Subject: STA File # 0024-EX-ST-2001, Confirmation Number: EL10766
Reference: OET correspondence, February 05 2001, 3:30 PM

Exhibit 1 0024-EX-ST-2001 STA Application

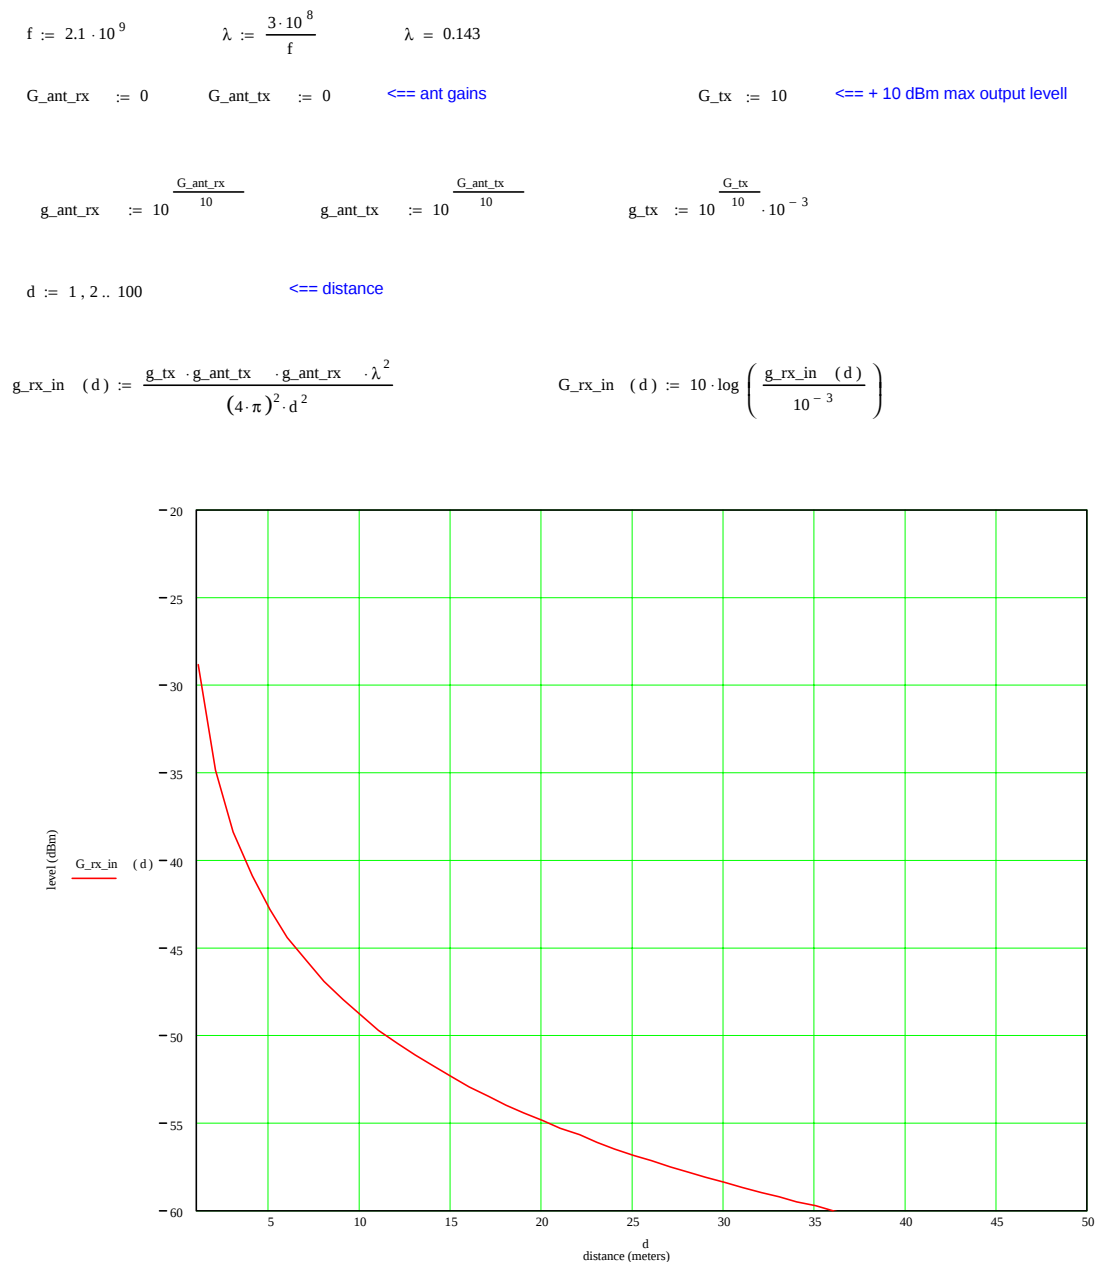
1. I modified the frequency to read 1930-1990 MHz (same as our earlier authorization (0447-Ex-ST-2000)).
2. I modified UMTS frequency to 2150 to 2160 MHZ and the maximum transmit power to +10 dBm.

The tests will be done inside the laboratory. The laboratory is big enough to attenuate the signal by more than 50 dB. In addition the signal (+10 dBm) is spread in a 3.84 MHz BW and the following calculations show that the signal will be attenuated more than 50 dB in the lab.
